1000 VAN NESS AVENUE MIXED USE DEVELOPMENT/THEATER COMPLEX

Final Environmental Impact Report

94.618E
State Clearinghouse No. 95123031

FIGURE 1

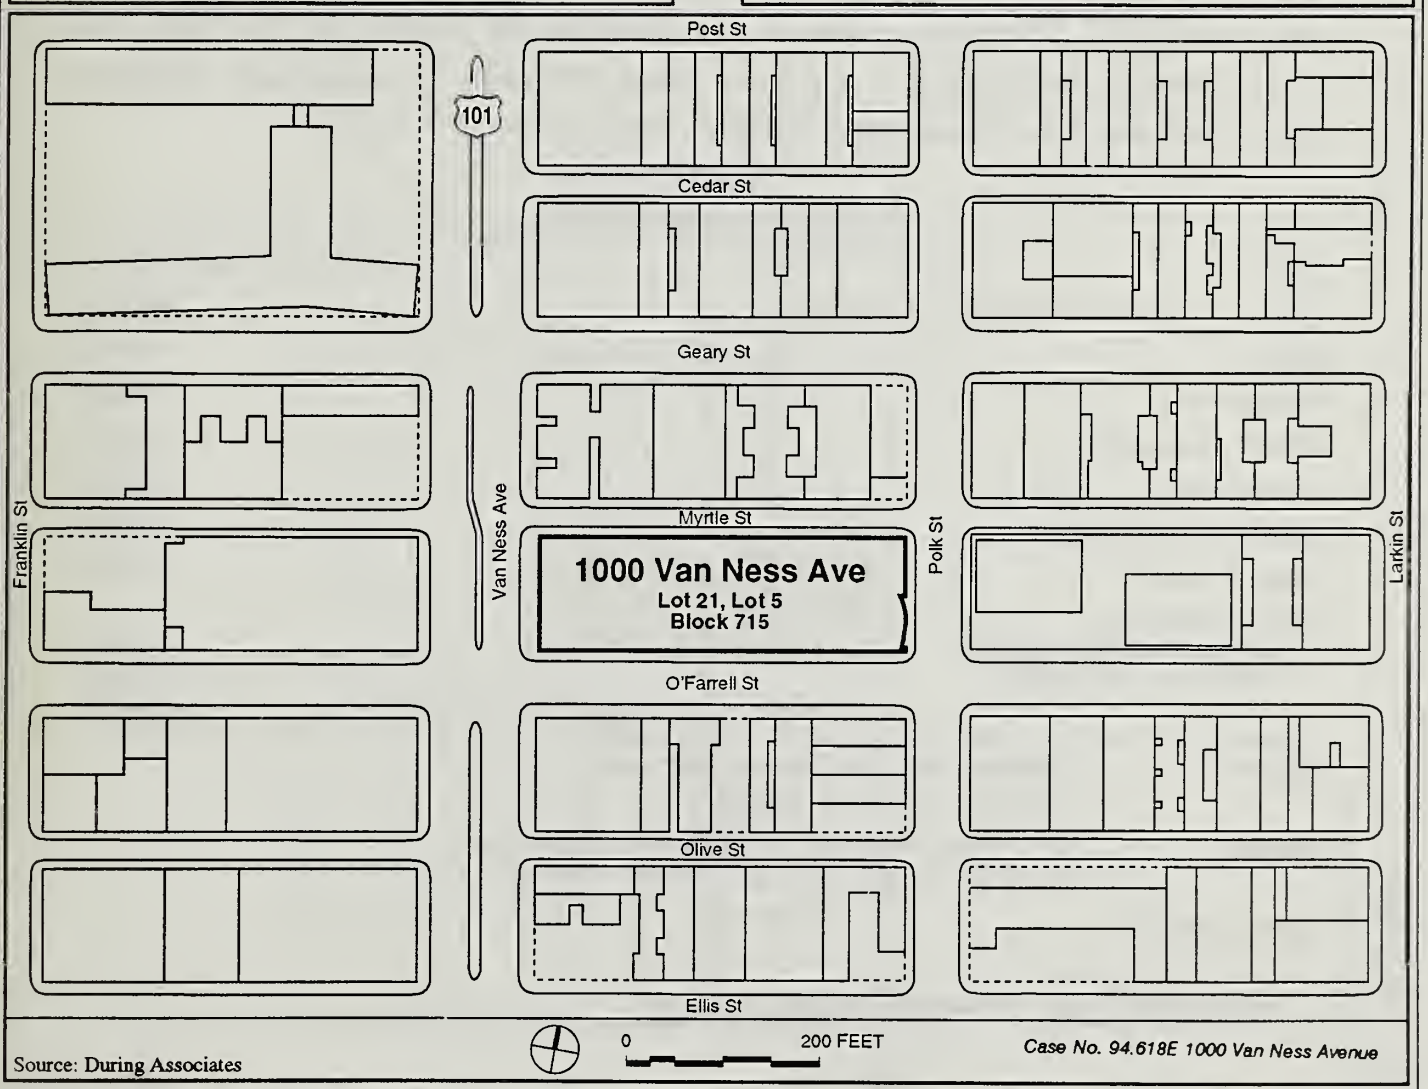
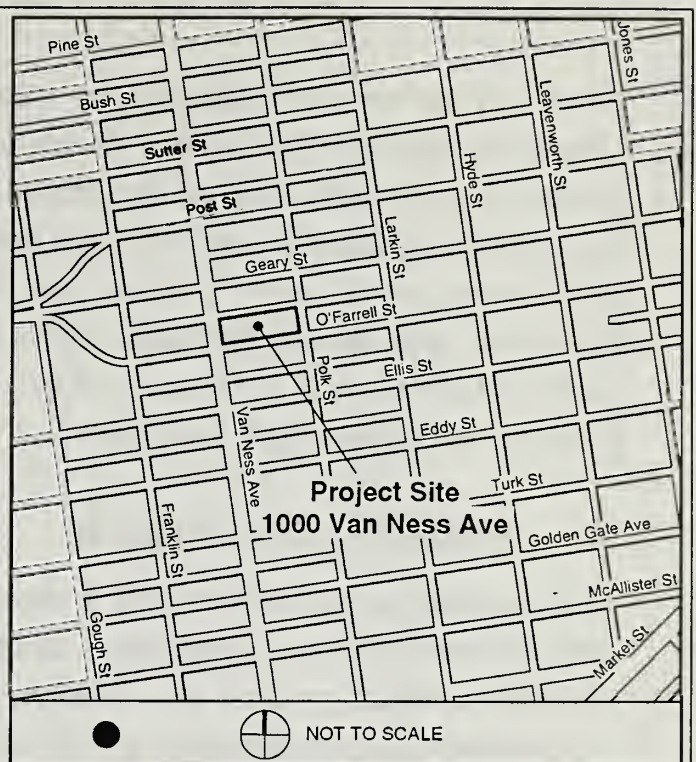
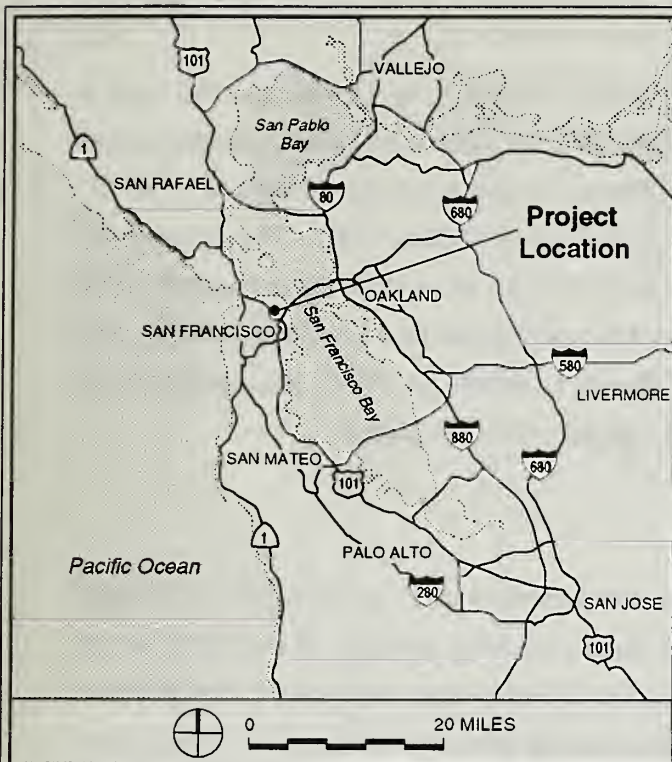
Page 21, Figure 1, map on upper right of page, change "Post Street" to "Sutter Street" and "Sutter Street" to "Post Street."

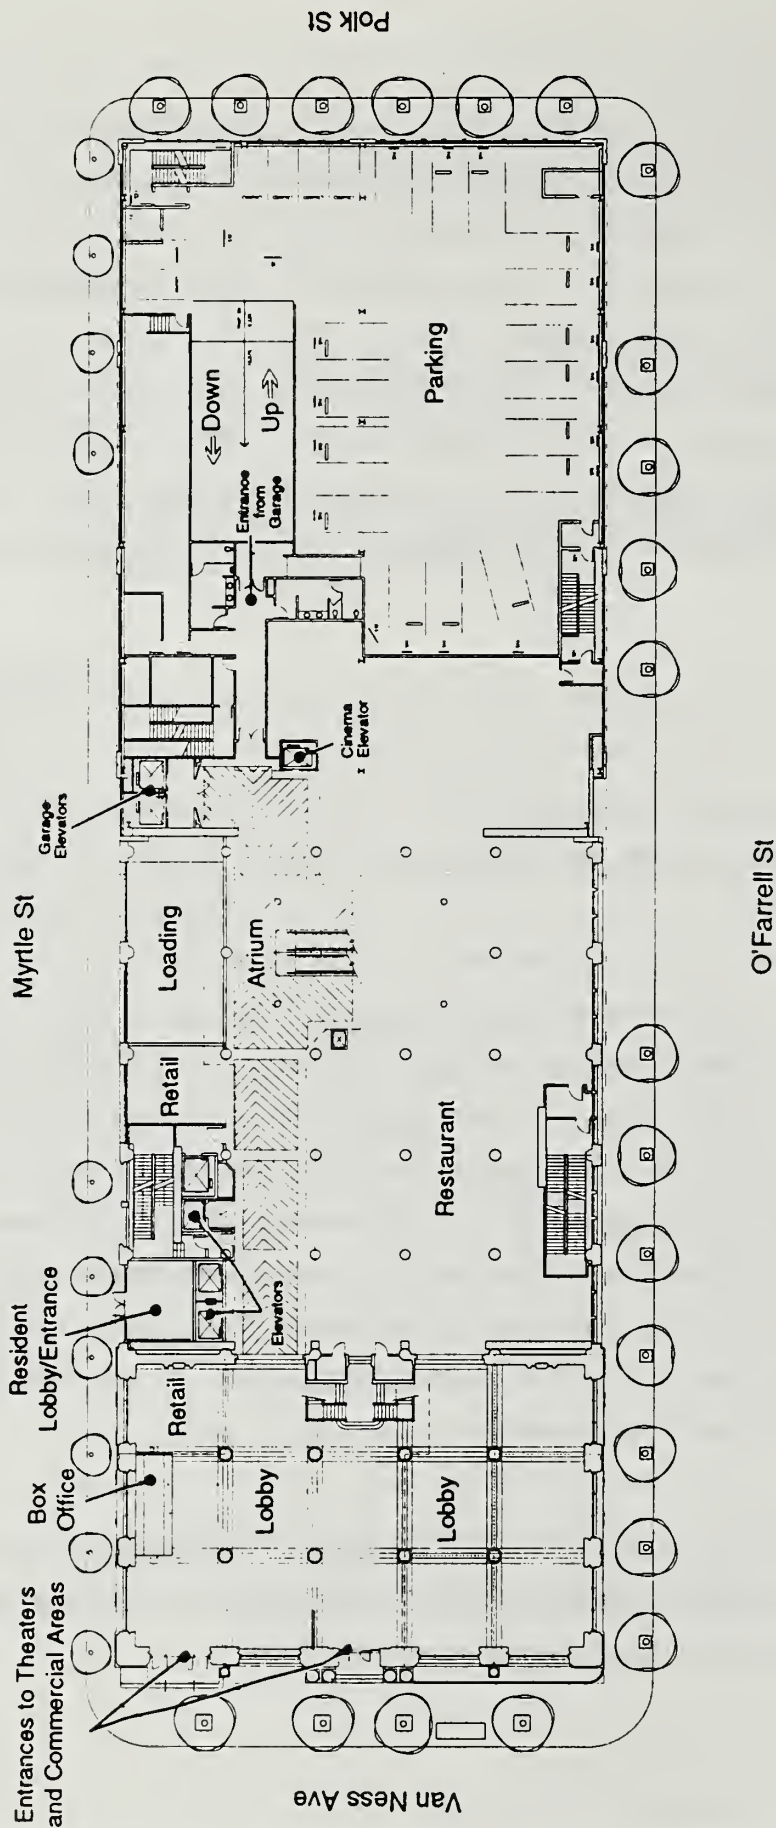
"Visual impact of the blocky upper story form of the theaters with virtually blank facades on O'Farrell and Polk Streets would be highly negative to the character of the retail streets, almost like adding a warehouse.

"Users of the podium level open space on the residential development across Polk Street will look into a blank facade and will lose afternoon sunlight. The setback of this residential development [across Polk Street] was a gracious one, intended to ameliorate the effect on Polk Street of the block tower of units. The theater development would erase the beneficial effect of this setback on Polk Street. Addition of vertical banks of glazing (which are meant to simulate curvilinear bay windows?) on the O'Farrell frontage is inexplicable and appears to relate to nothing on the interior plan. These banks of glazing do not relate to the historic facade on the same street and appear thin and trivial compared to the adjacent historic frontage. The curvilinear bowing of a portion of the upper Polk Street facades, apparently to express the form of the back of the theaters there, is commendable but does little to articulate the facade and nothing to enhance the streetscape. The theater volumes could be broken into shadow casting elements and articulated in a more satisfactory way." (Jennifer Clary, San Francisco Tomorrow)

The design of the exterior of the Polk Street addition to the existing 1000 Van Ness Avenue Building is still being refined by the project sponsor in conjunction with the City Planning Department, Landmarks Preservation Advisory Board and the State Office of Historic Preservation. Modifications to the design are shown in the revised floor plans (Revised DEIR Figures 3 and 4, pages C&R.9 and C&R.10), the revised O'Farrell Street and Polk Street Elevations (Revised DEIR Figures 5 and 6, pages C&R.11 and C&R.12), and the photomontages (Revised DEIR Figures 13 and 14, pages C&R.13 and C&R.14).¹ The modifications consist of refinements in the design (for example realigning the interior staircase on the O'Farrell Street side). There would be no change in the development program.

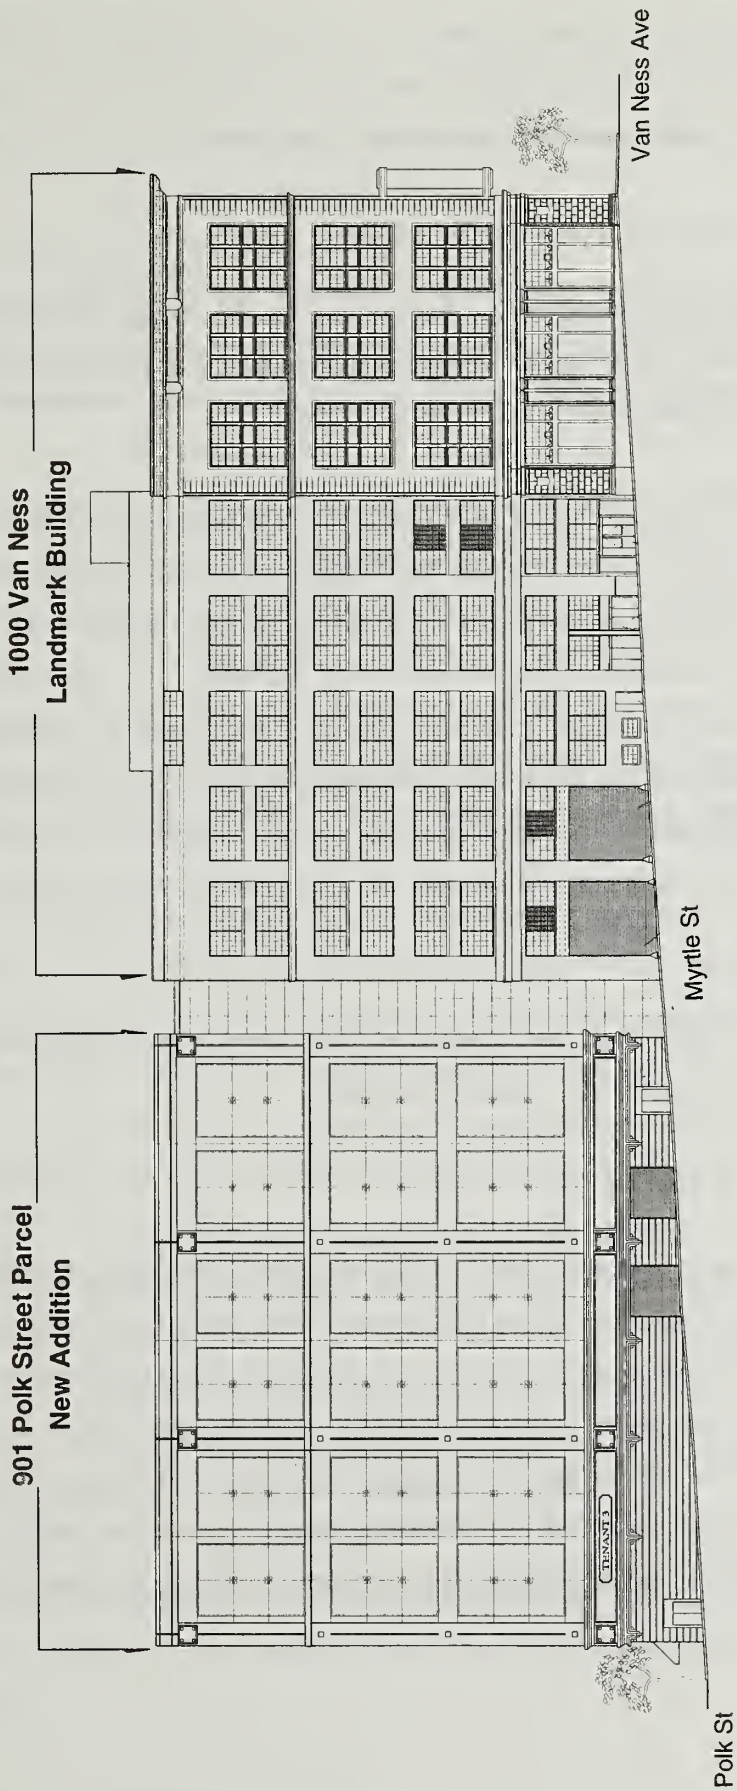
"No elevation is shown for the Myrtle Street facade. The entrance to the residential units will be overwhelmed by the expanse of blank wall on the alley and may be unsafe if there are no 'eyes on the street'." (Jennifer Clary, San Francisco Tomorrow)

A Myrtle Street elevation has been provided (C&R Figure 1, page C&R.16). As shown on the Myrtle Street elevation and in the revised Ground Floor Plan in Figure 3 on page C&R.9, the entrance to the residential units would be in the western half (in the fourth bay) of the 1000 Van Ness Avenue building which has windows on the entire north facade. The north facade of the Polk Street addition would not have windows. Street trees would be introduced along Myrtle Street. Security for the residential units would be provided via security lighting along Myrtle Street, as well as card key accesses to the residential lobby and elevators.¹
